Technical Service Information

THM 3T40 (125C) NEW DIRECT CLUTCH HOUSING

Figure 1

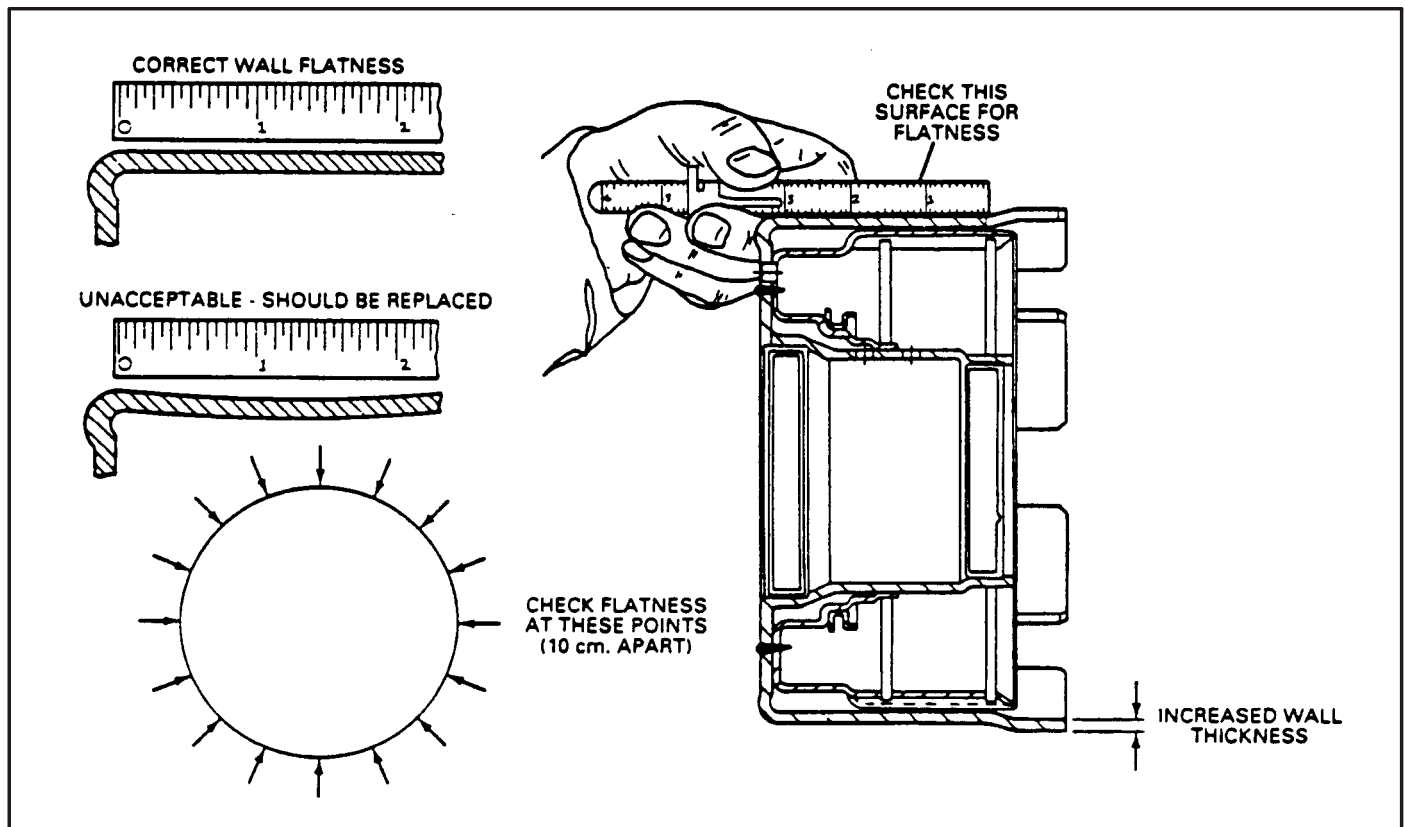
CHANGE: A new Direct Clutch Housing went into production on July 12, 1989 (Julian Date 193 for all THM 125C (3T40) transaxles.

REASON: To prevent the Direct Clutch Housing from warping when subjected to excessive heat from the intermediate band.

DIRECT CLUTCH HOUSING - Increased the wall thickness .008" (Figure 1).

The new Direct Clutch Housing can be used on previous model 125C transaxles back to 1985 only.

The new Direct Clutch Housing cannot be used on 1980-1984 model 125C transaxles, because the snap ring location will not allow installation of the internal parts from those model years.
